MEMORANDUM

DATE: October 26, 2015
TO: Mayor and City Council
FROM: Phil Jones, City Administrator
RE: 3rd Street SE Bridge Status and Timeline

RE: City of Waverly
3rd Street SE Bridge
Discussion of Bridge Closure

Figure 3: Deterioation at Bearing - Truss Gusset Plate Not Connected to Pin

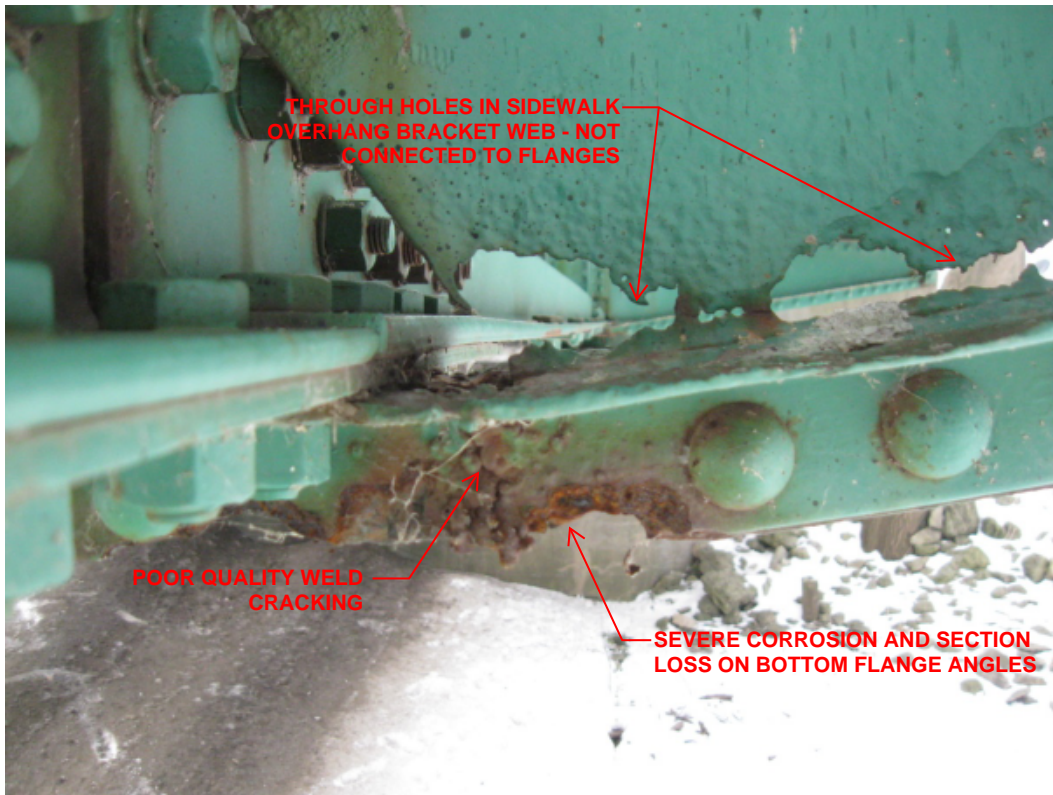
- Cracks in the webs of two stringers
- Deteriorated bearings
- Advanced section loss of the sidewalk overhang bracket

Consequences of Bearing Failure

A truss is a fracture critical structure because it lacks redundancy, or the ability to redistribute loads to other members if one should fail. If a single bearing failed and the bridge dropped at one corner there would be significant impact to the entire truss. The entire truss would be subject to loads it was not designed for as the span warps in response to the relative
